M-I-18-3

January 19, 2018

SUBJECT: Answers To Questions Received From The Field; Regional Milk Seminars; And FDA Training Courses Held During Fiscal Year 2016

**Refer to Flow Diagram below:**

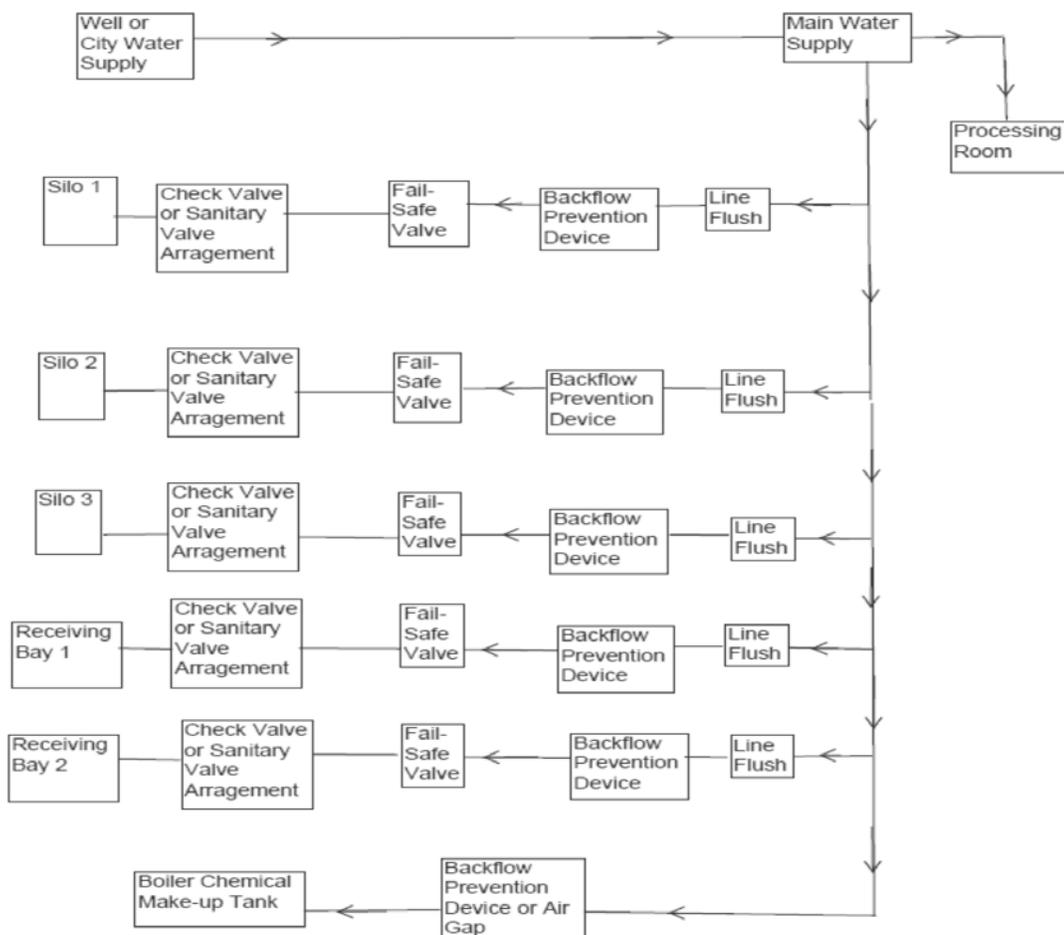
c) If the water line that supplies water to the silo flush lines in the raw milk silo room continues on and supplies water to pipeline flushes located in the receiving bay and/or other locations throughout the milk plant, are backflow prevention devices required on each individual silo flush line (point of application) located in the raw milk silo room?

*Yes. The fail-safe valves described in b) above will not protect against backflow or backsiphonage. If backflow or backsiphonage were to occur, milk and/or milk product could be drawn into the water line through the fail-safe valves installed on the individual silo flush lines located in the raw milk silo room. If this were to occur, the water supplying the pipeline flushes located in the receiving bay or other locations throughout the milk plant would not be considered safe and of a sanitary quality.*

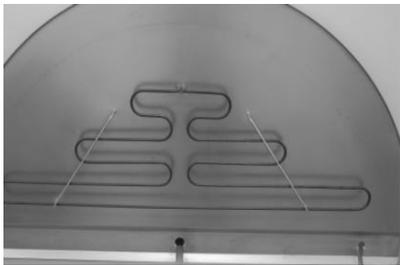
May an electric heater coil, as shown below, be used as an airspace heater in a batch (vat) pasteurizer? If it can, what are the construction and size requirements of the electric heater coil?

***NOTE:*** *The Regulatory Agency may use the requirements of Section E1.15 and validation data per Appendixes J and K of 3-A® Sanitary Standard 24-03 and the applicable PMO requirements related to material, construction, cleanability, etc. to review and accept, or reject, the use of a radiant heating element for air space heating.*

*After reviewing the pictures that were submitted on the proposed electric airspace heater coils as shown below and additional information provided and gathered by FDA MSs, based on the requirements of the PMO it would be very difficult to accept these electric airspace heater coils for use as airspace heaters in batch (vat) pasteurizers utilized in Grade “A” milk plants. The use of an electric airspace heater coil would not assure the proper heat dispersion throughout the airspace of the batch (vat) pasteurizer. Temperature is directly proportional to the distance that the airspace thermometer sensor is located from the electric airspace heater coil. Therefore, the proper placement of the airspace thermometer in the batch (vat) pasteurizer would be difficult to determine.*
